UNITED STATES PATENT AND TRADEMARK OFFICE

APPLICATION NO.	FILING DATE	FIRST NAMED INVENTOR	ATTORNEY DOCKET NO.	CONFIRMATION NO.
09/812,437	03/20/2001	Dagnachew Birru	US010069	9839
24737	7590	07/19/2005	EXAMINER	
PHILIPS INTELLECTUAL PROPERTY & STANDARDS P.O. BOX 3001 BRIARCLIFF MANOR, NY 10510			DEPPE, BETSY LEE	
			ART UNIT	PAPER NUMBER
			2637

Office Action Summary

DETAILED ACTION

Fig. 3

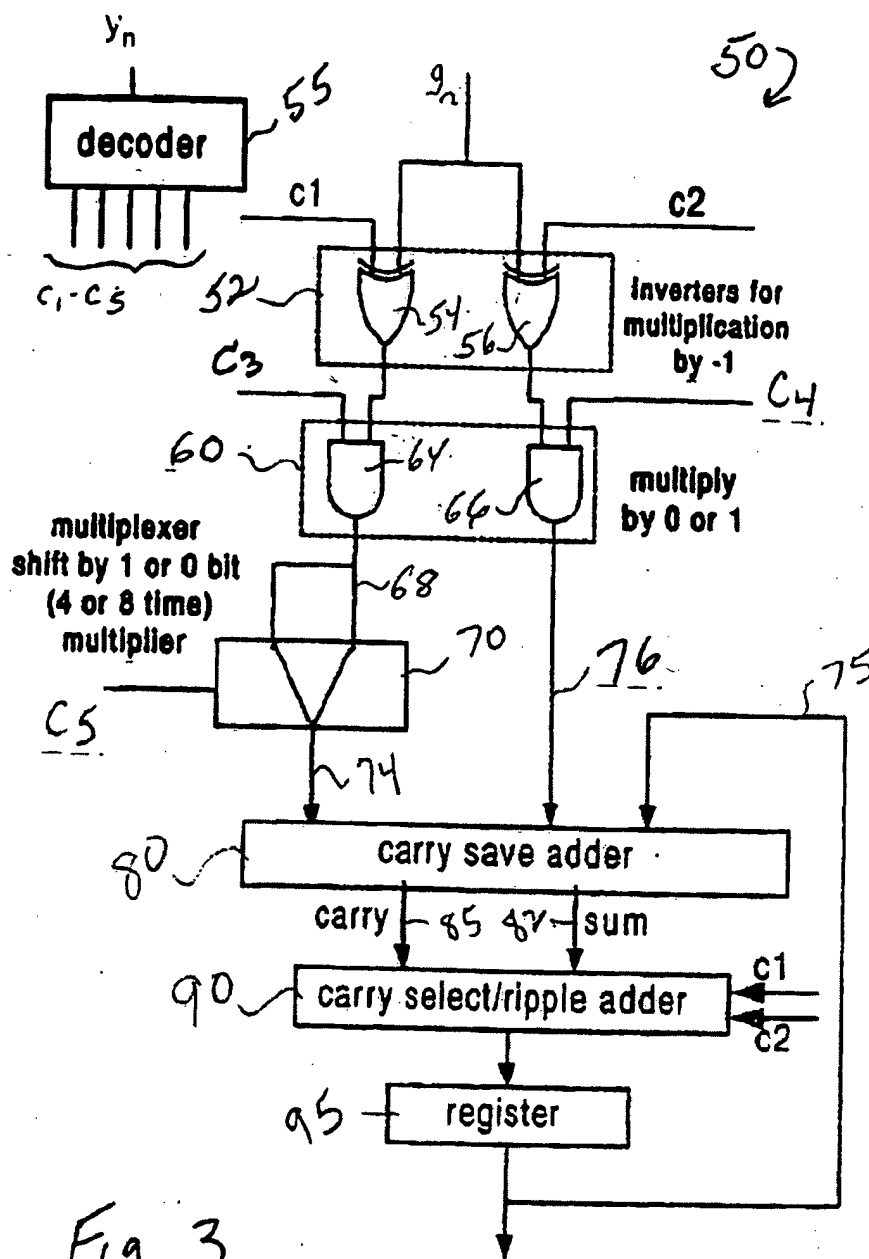
10. In claim 11, it is unclear how the error value is implemented as a discrete digital level value for use by the multiplier device. Furthermore, the specification does not describe how the error signal in Figure 1 is used by the multiplier device in Figure 3.
